**Response to Request for Information**

**17 – 21 Pennsylvania Road, Riverwood (DA-757/2020)**

This response has been prepared by *Keylan Consulting Pty Ltd* (Keylan) on behalf of *St George Community Housing* (the Applicant) in response to Council's email dated 23 April 2021 in relation to the above development application (DA-757/2020).

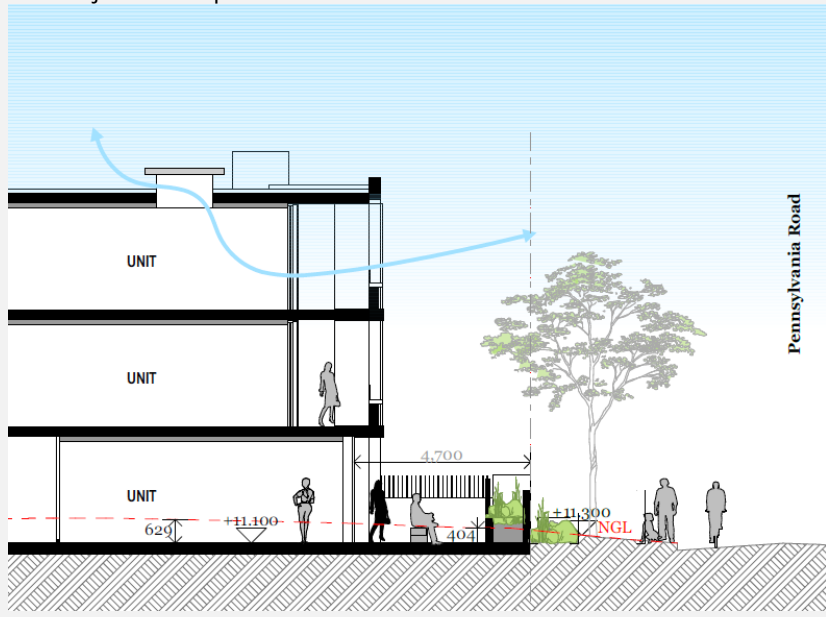
5	<p><b>Waste</b>  <i>Areas to address with the bin storage area:</i></p>	<p>The Ground Floor Plan (DA201) provided at Attachment B has been revised to include the required 15cm gap and the placement of the bins to allow for the bins to open from the long side.</p>

Ref.	Council Issue	Response
	<ul style="list-style-type: none"> <li>660L bins open along the long side, this must be the side pointing outwards for residents to be able to place their rubbish inside the bin.</li> <li>Bins should be separated by at least 15cm gaps to allow for them to be moved into position.</li> </ul>	A revised Operational Waste Management Plan (OWMP) has also been provided at Attachment D.
6	<b>Other</b> <ul style="list-style-type: none"> <li>Need to remove substation along Hunter St from the plans (this is an error as they relocated it, new location is integrated into the building along the Union St frontage)</li> </ul>	The Revised Architectural Package provided at Attachment B has been updated to reflect the relocation of the substation.
7	<ul style="list-style-type: none"> <li>Get more information about the pop up vents and which units are relying on them for solar + ventilation</li> </ul>	<p>DKO has previously prepared a detailed section to demonstrate how natural cross ventilation can be achieved through pop up units. An updated section demonstrating how cross ventilation will be facilitated on the subject site is provided below:</p>
